MSO/MST Firmware 2.07.x bug list:

List of bugs/improvement requests

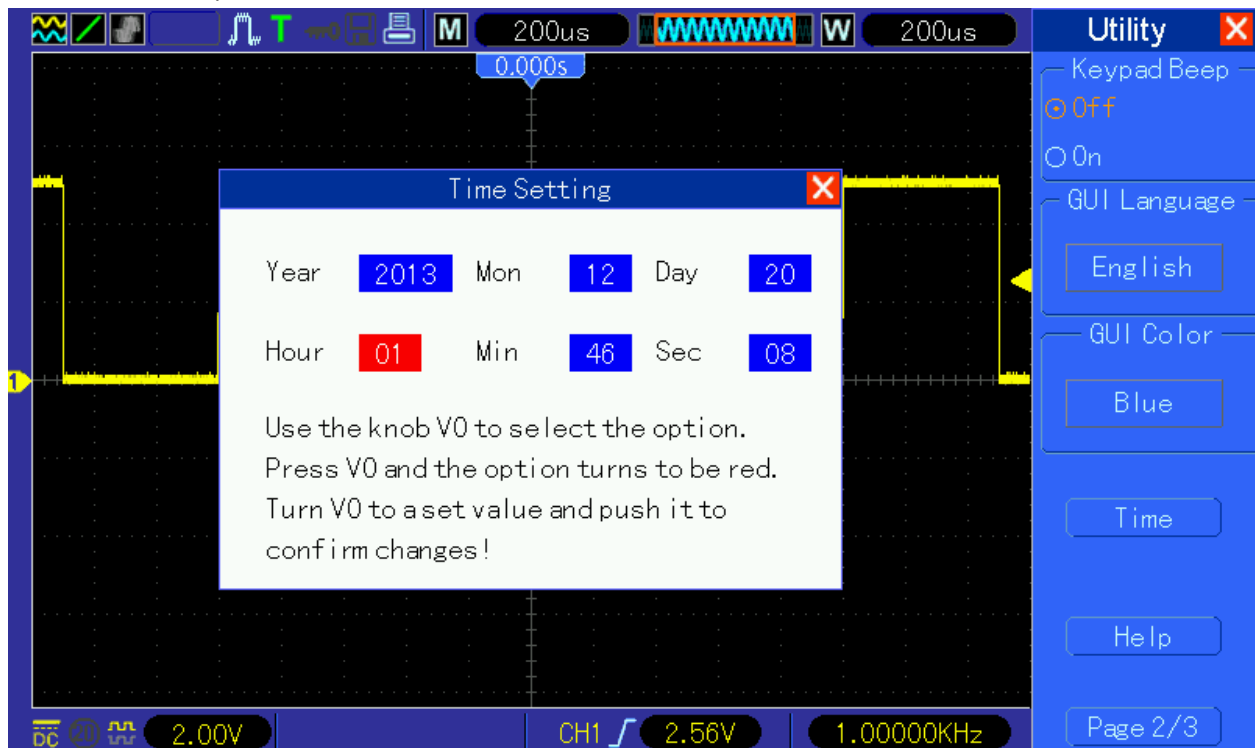
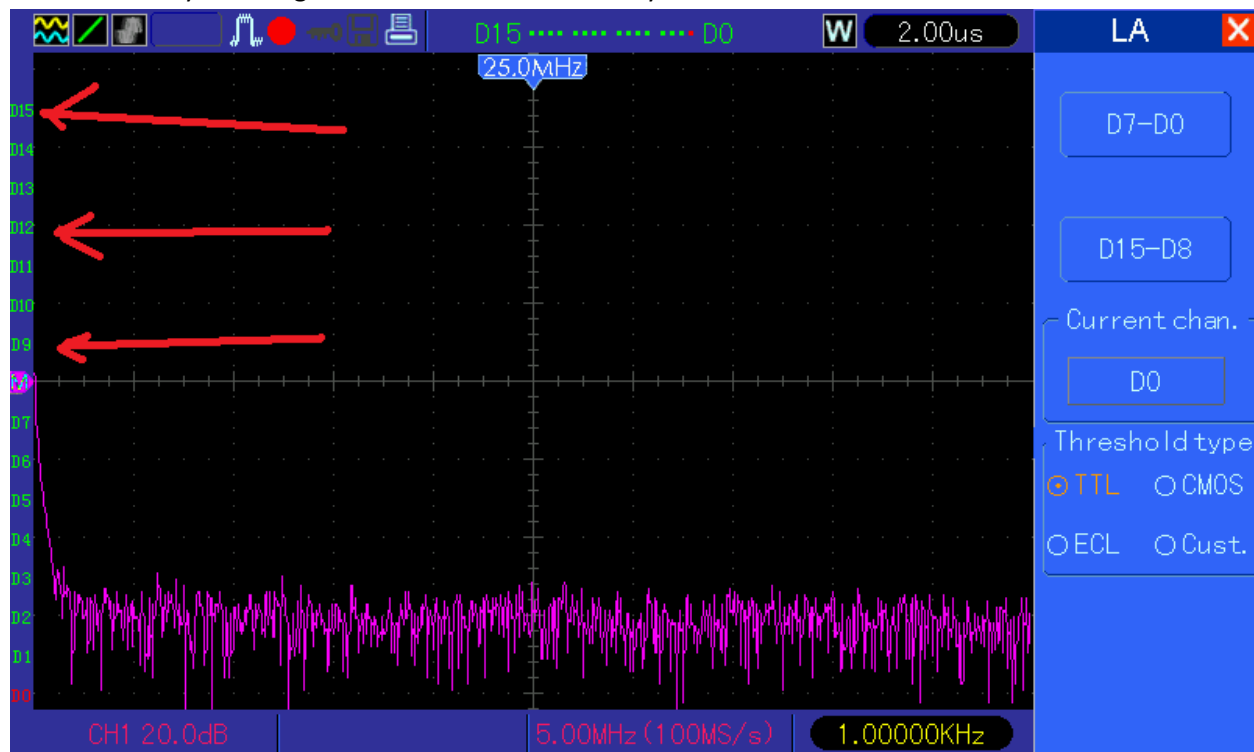
34. It is not possible to set 00:00 as time, the last possible hour is 23:xx:xx

the next hour step is not 00:xx:xx but 01:xx:xx

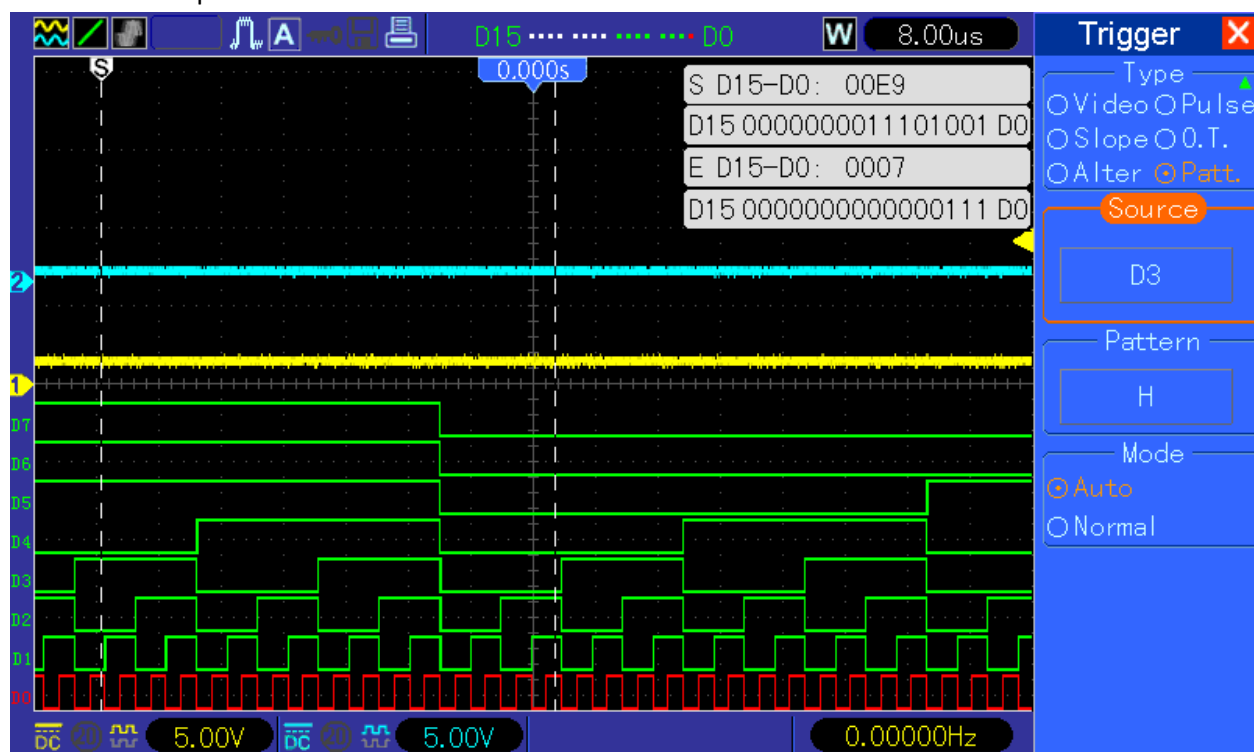
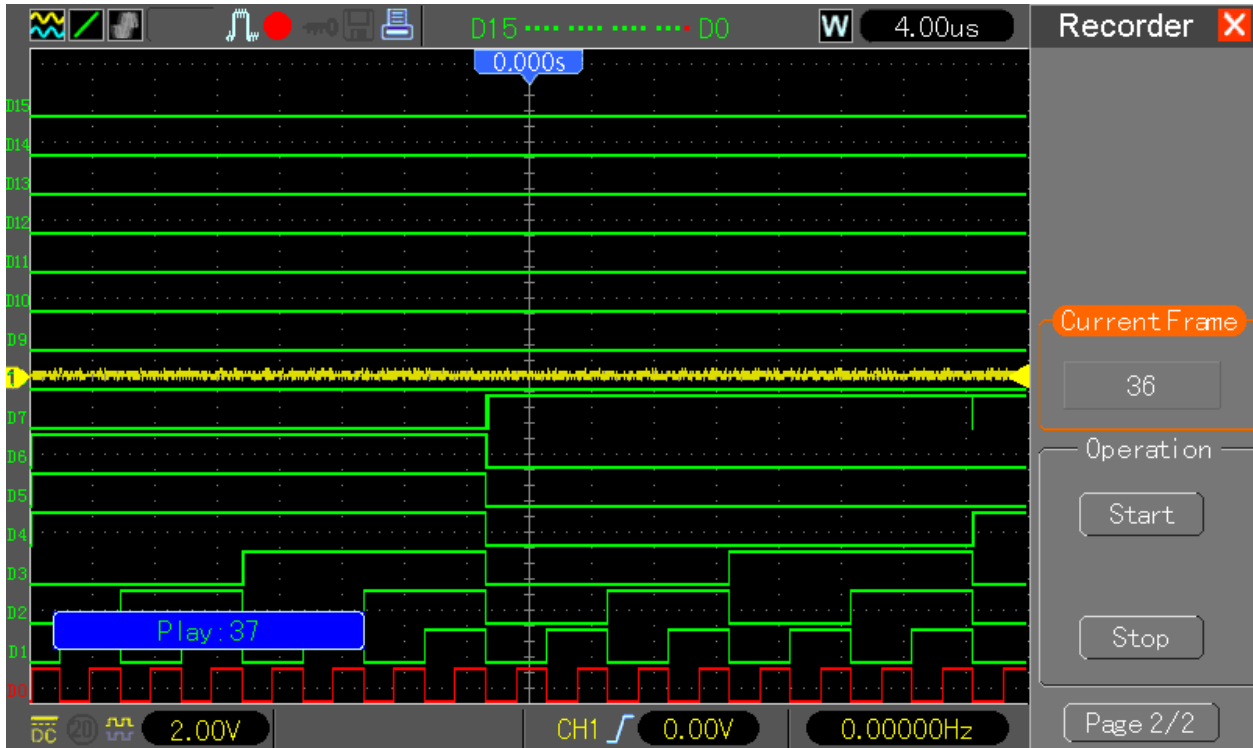
36. H and L letters swapped in Show_MenuItem3 function.

When I set "LA Pattern" trigger and create patter like 11111000 the LA is triggering on 00000111, cursor is showing as well 00000111. This means H and L letters are swapped in Show_MenuItem3 function. Binary (in dso.exe or dso_bin) in did search for 48 00 00 00 4C 00 00 00 58 00 00 00 and replaced with 4C 00 00 00 48 00 00 00 58 00 00 00 to fix that.

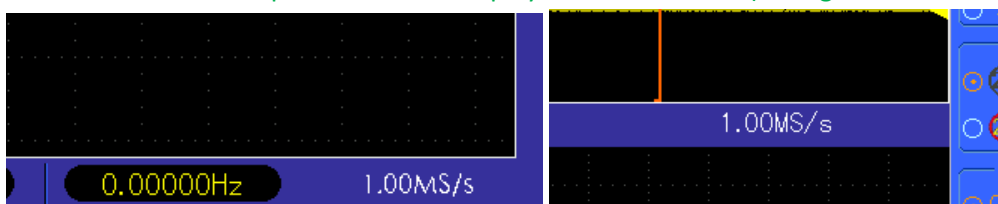
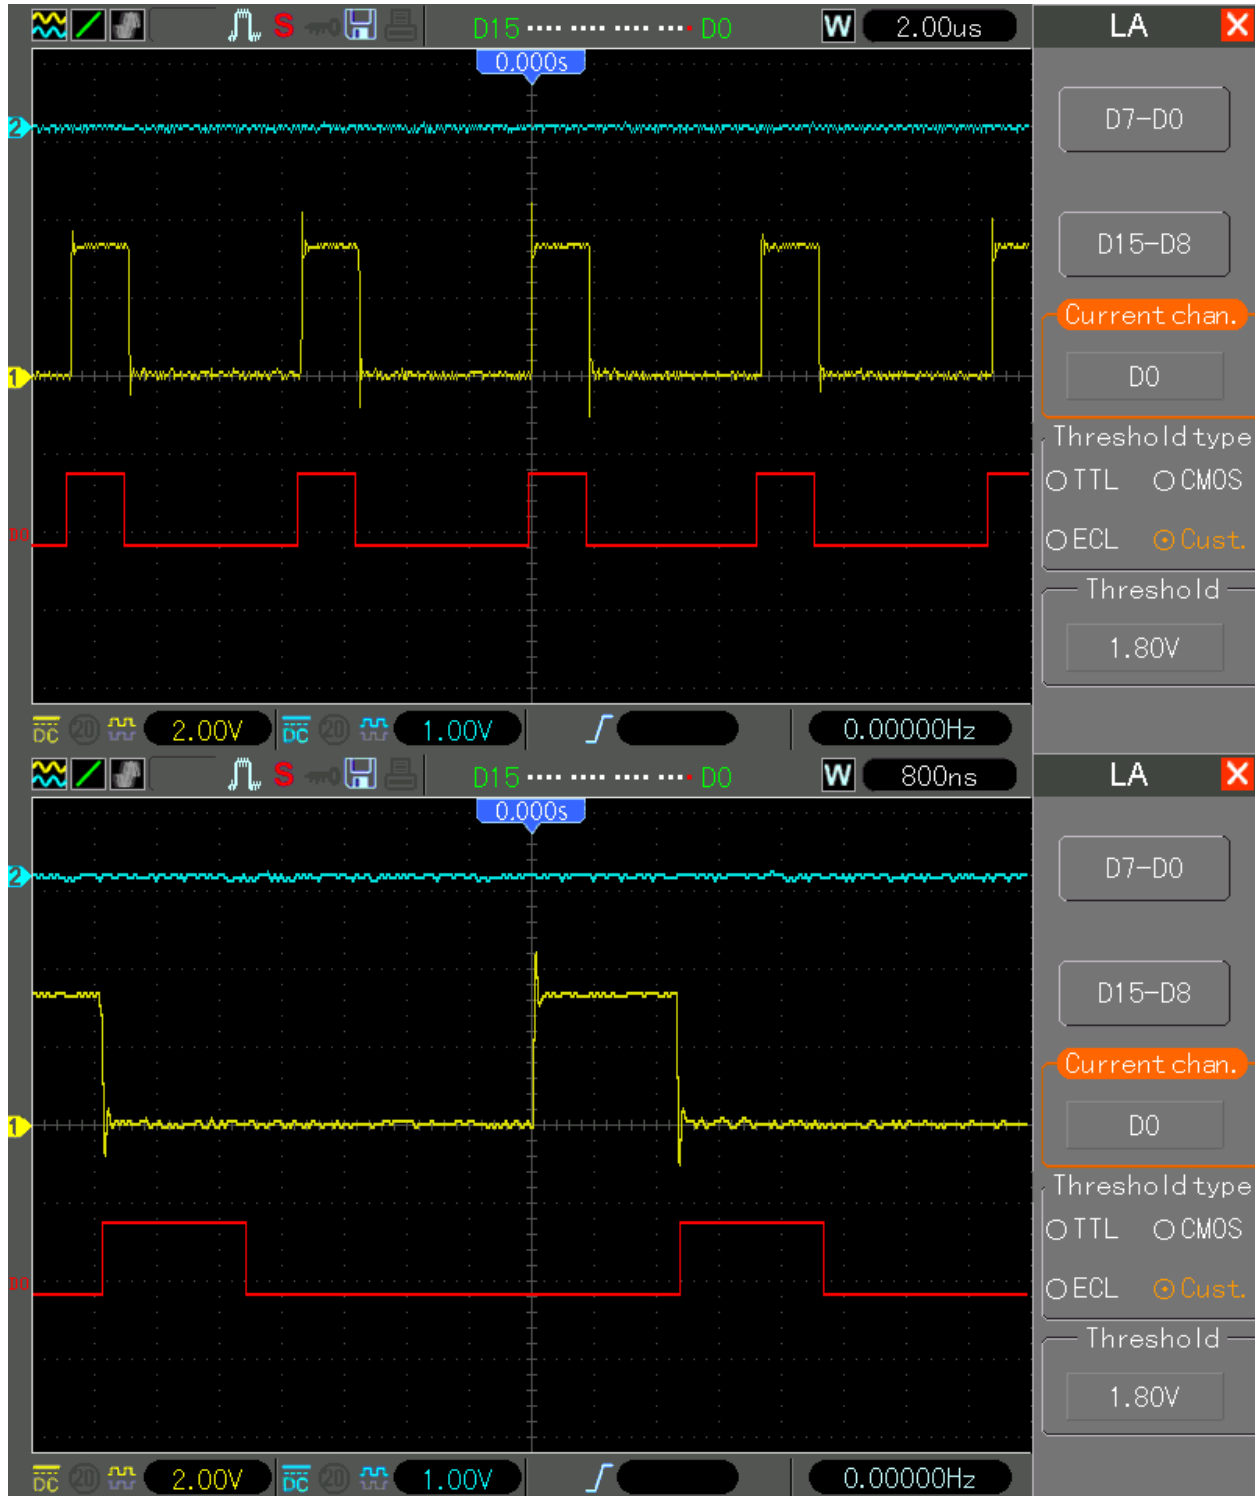
44. To avoid aliasing errors it is useful to know current sample rate. REQUEST: Add an option to select either “Time” or “Sample Rate” to be displayed in Status Area (in single and dual window):

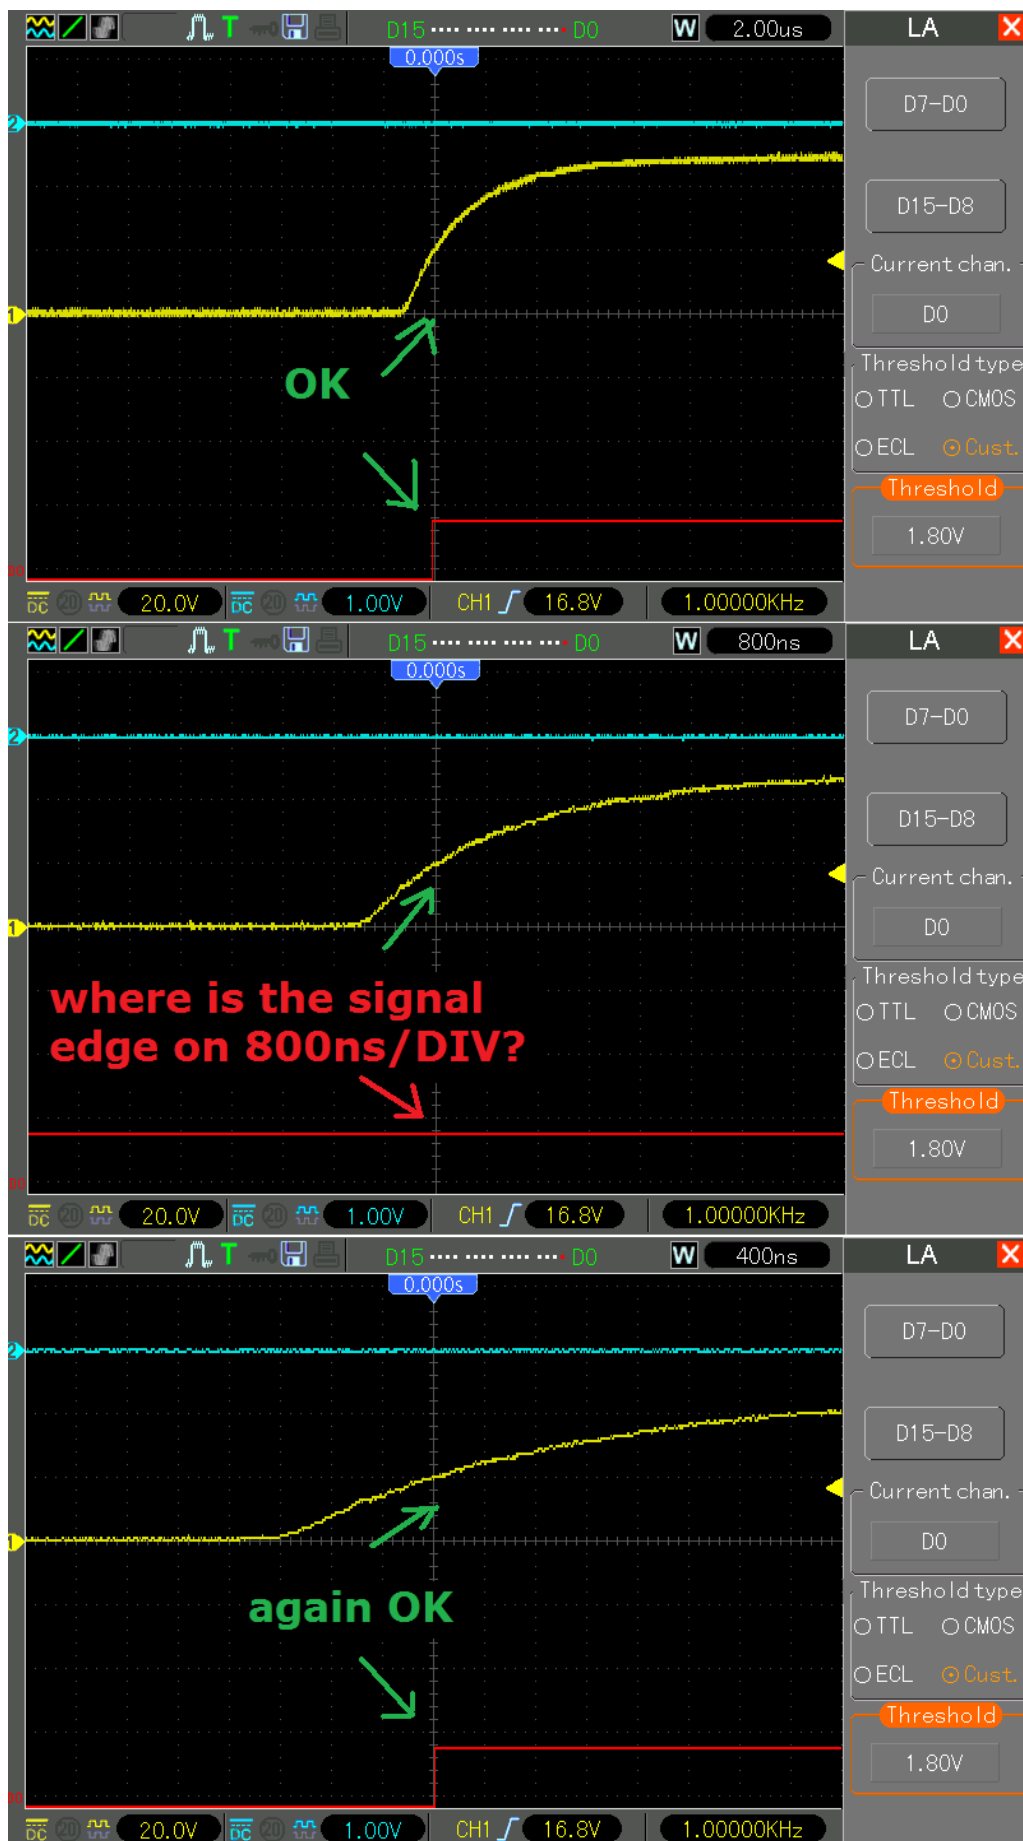
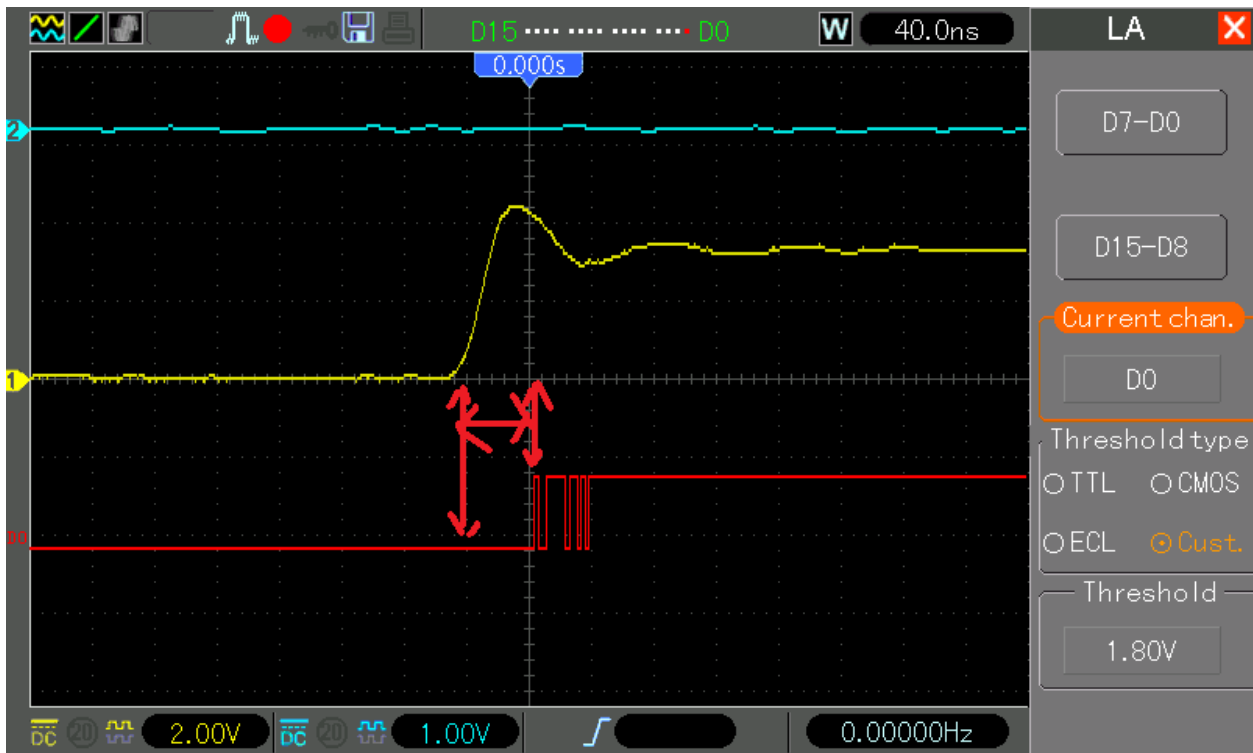
45. Error while zooming: signal previously sampled at 2us/DIV seems to be ok, but then when zooming to 800ns/DIV the LA seems to be delayed by the length of the analog signal pulse

another example, with slower signal – again, sampled at 2us/DIV, both LA and analog edges seems to be aligned, when changing timebase to 800ns/DIV the waveform is delayed, then at 400ns/DIV is again ok.
